ALAMITOS RIDGE SUPPLEMENTAL EIR
PROJECT ANALYSIS, EIR ERRATA, AND
RESPONSE TO COMMENTS

LONG BEACH, CALIFORNIA

February 2004

Volume 3B. Response to Comments

FIGURE 4.9.8

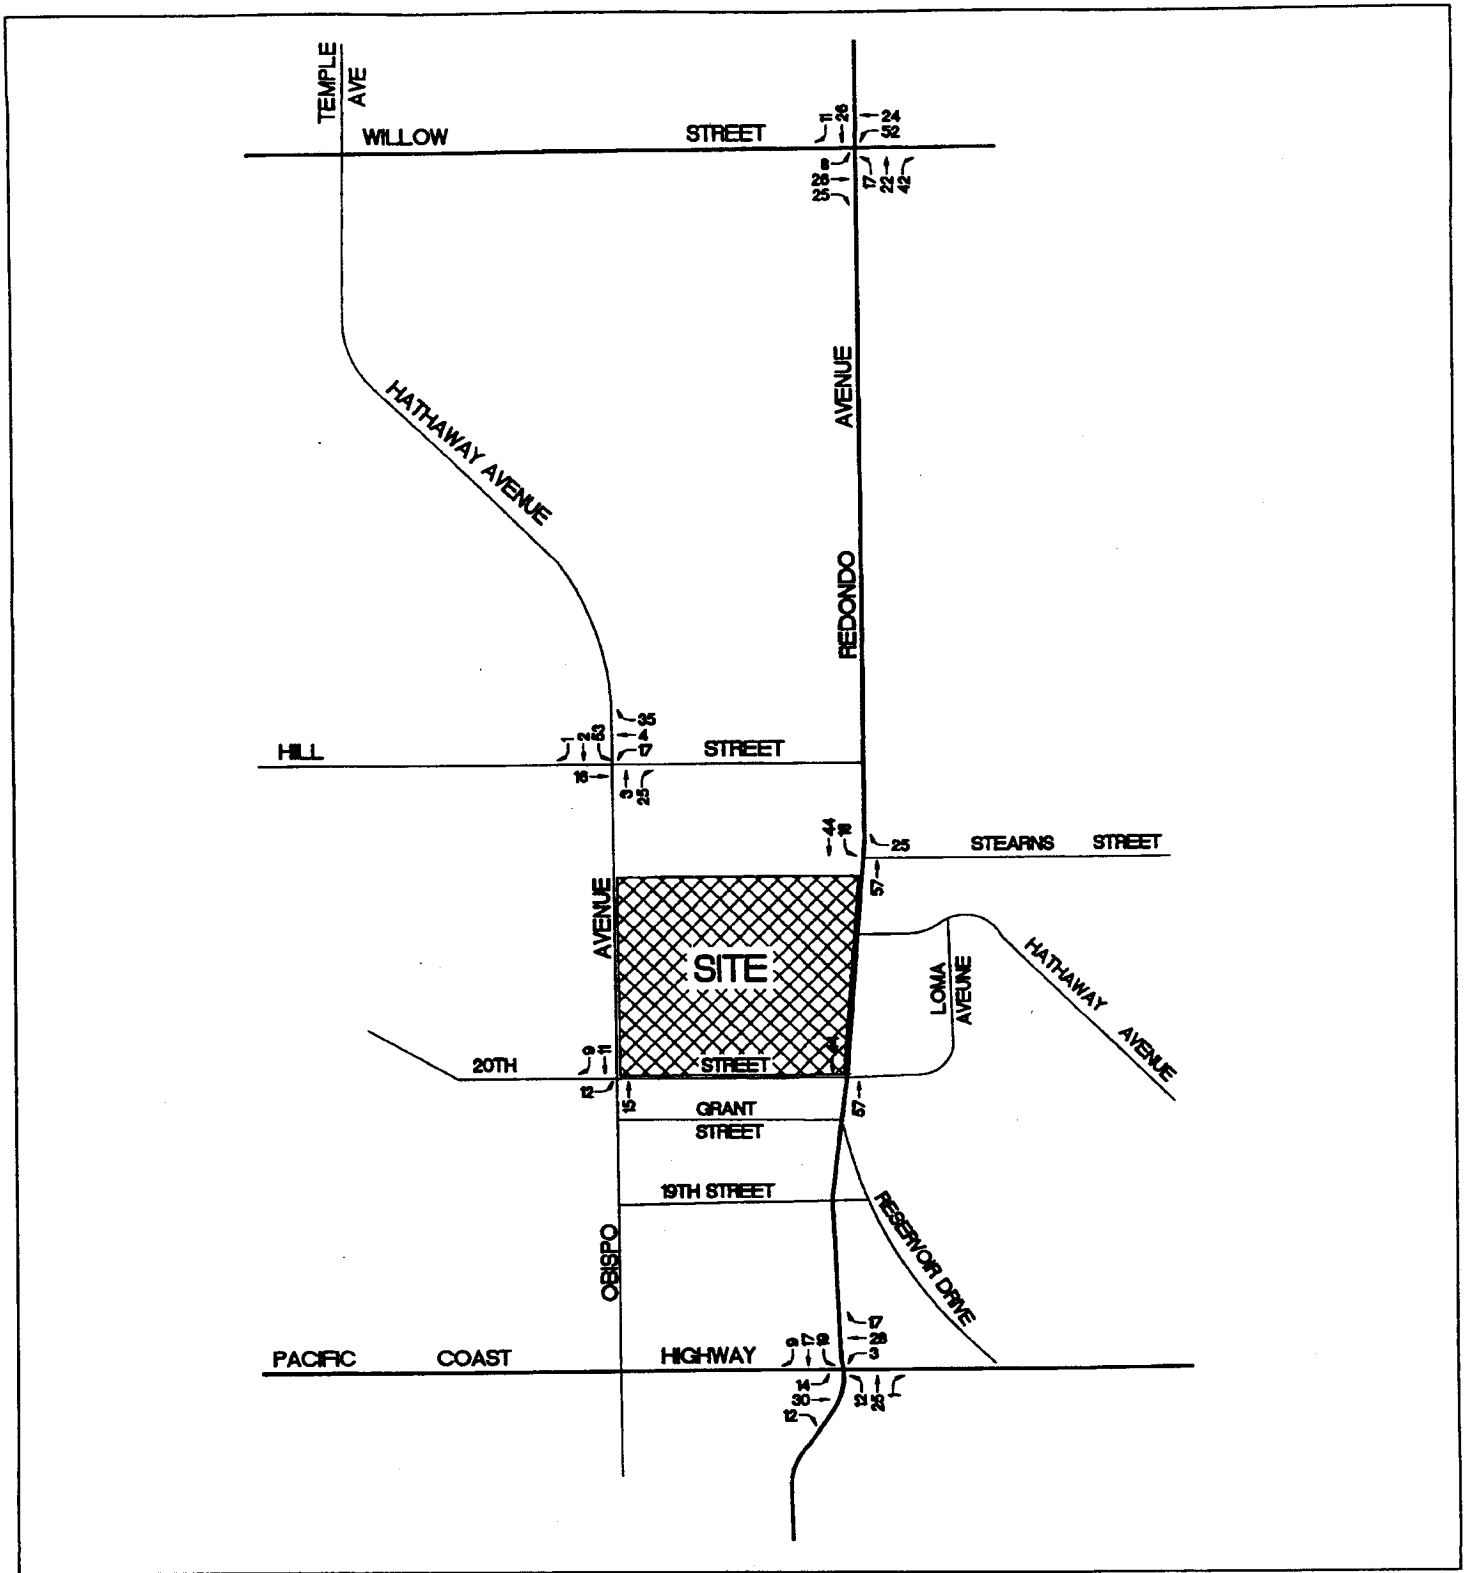
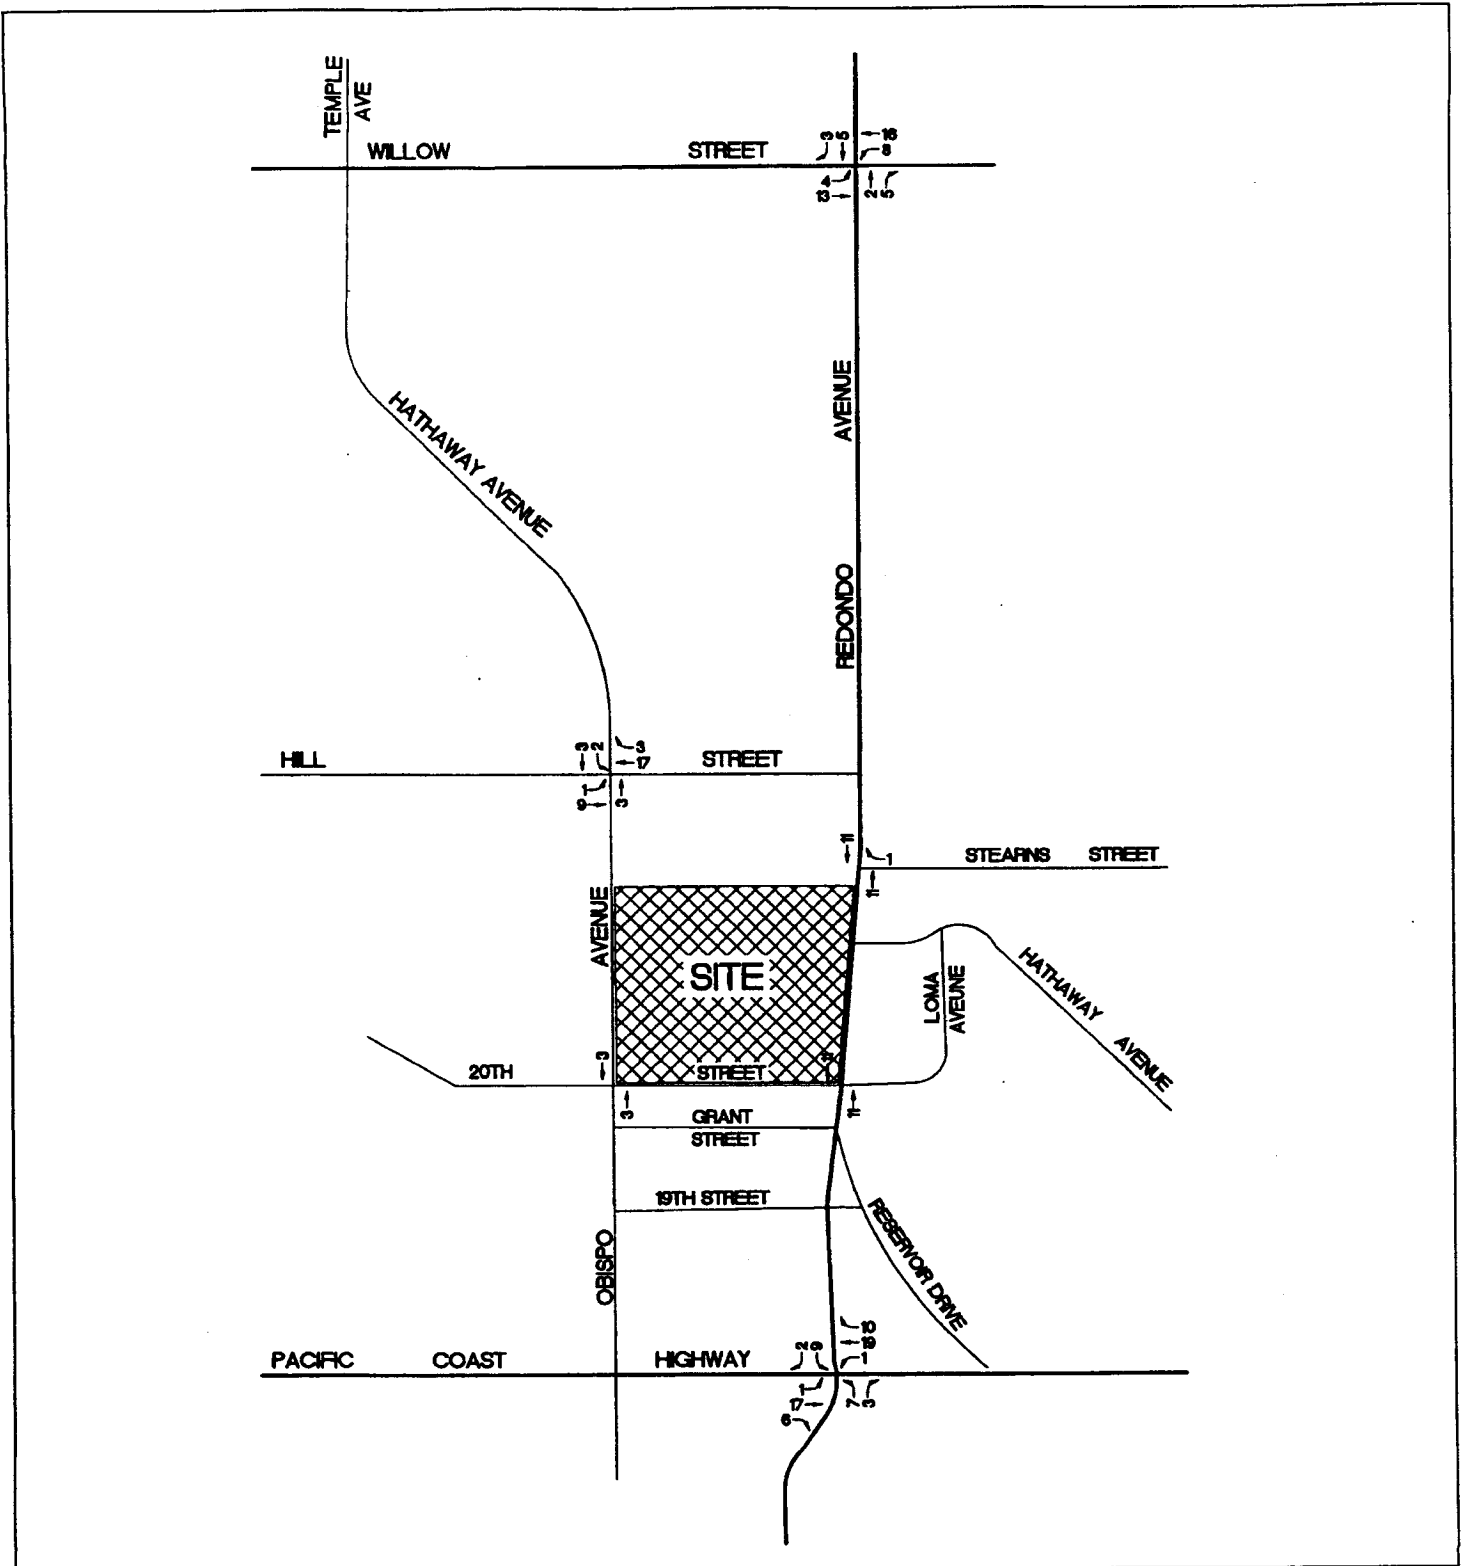
The report does not adequately report related projects nor does it show the trip generation and distribution of related projects. Review of related projects traffic presented on Figures 4.9.8 and 4.9.9 shows very low peak hour trips at Obispo/Hill. Since this intersection will be a main access to the proposed 1450 student K-8 school the numbers presented do not adequately represent expected traffic to/from the school.
